**SHEARON HARRIS NUCLEAR POWER PLANT, UNITS 2 AND 3
DOCKET NOS. 52-022 AND 52-023
RESPONSE TO SUPPLEMENTAL REQUEST FOR ADDITIONAL INFORMATION REGARDING
THE ENVIRONMENTAL REVIEW**

**Shearon Harris Nuclear Power Plant Units 2 and 3
Response to NRC Supplemental Request for Additional Information Regarding the
Environmental Review for the Combined License Application, dated October 30, 2009**

NRC RAI #: 5.4.2-2

Figure 1
Results of Tritium Evaluation

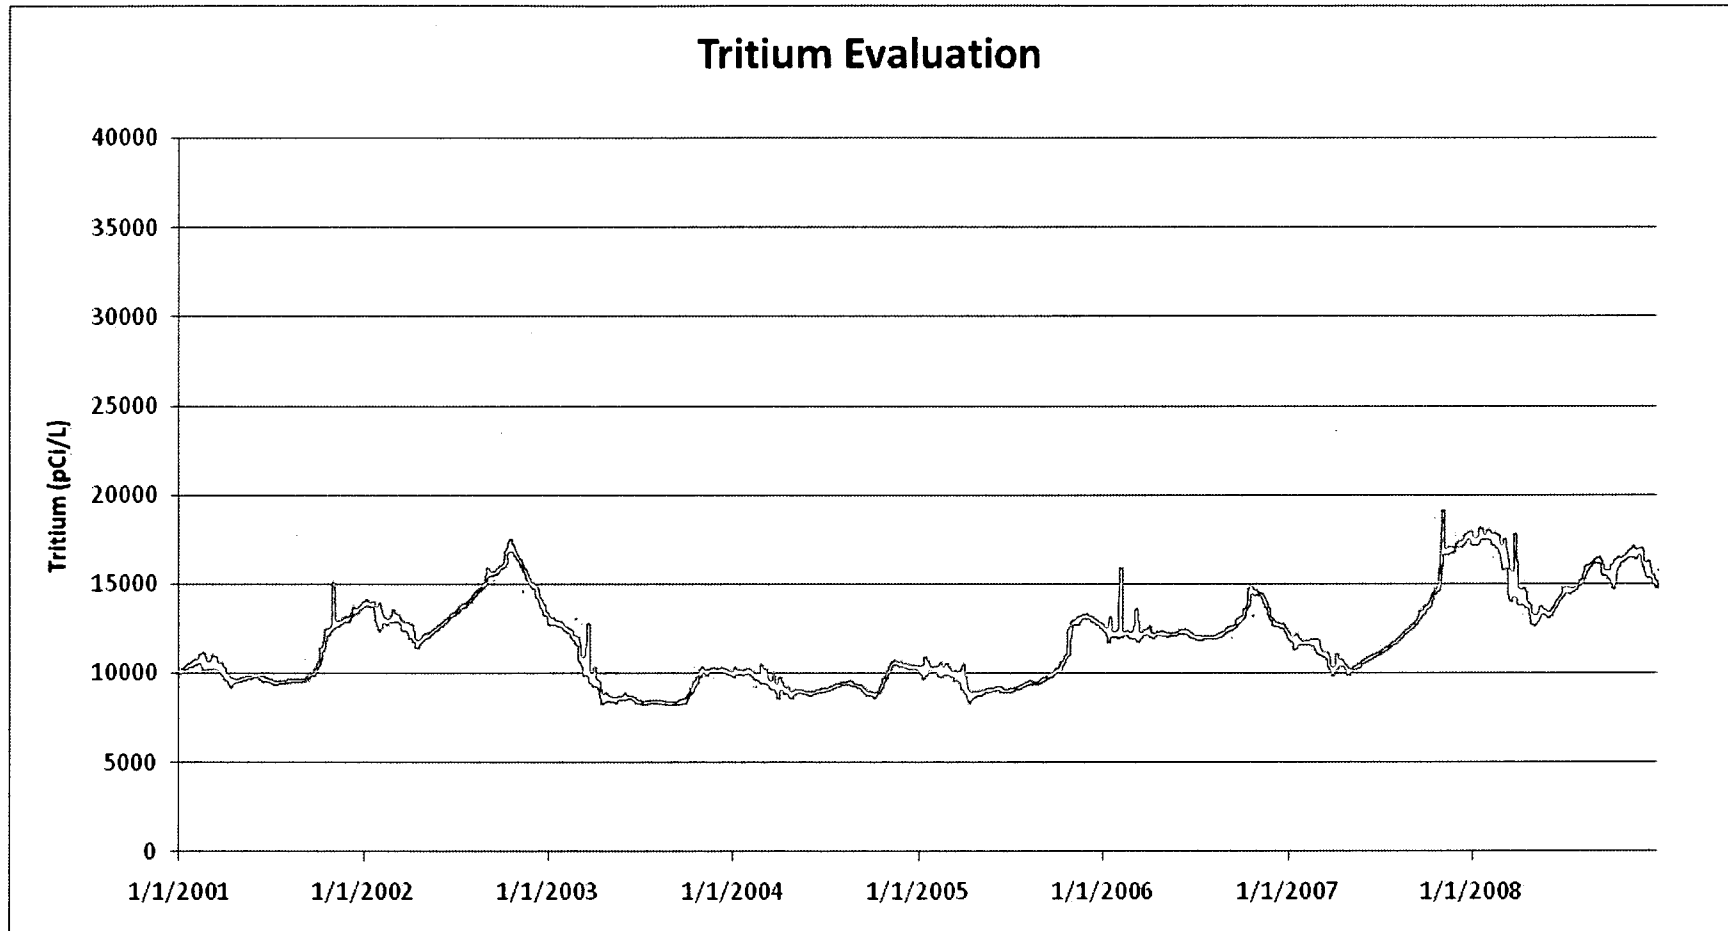
Provide an evaluation of the potential tritium buildup concentration (in pCi/L) in the Harris Reservoir from the addition of liquid effluents containing tritium from the operation of Units 2 and 3.

The predicted tritium levels in the lake segment downstream of the discharge for the proposed reactor scenario are shown on Figure 1. Tritium levels never exceed a level of 20,000 picocuries per liter (pCi/L).
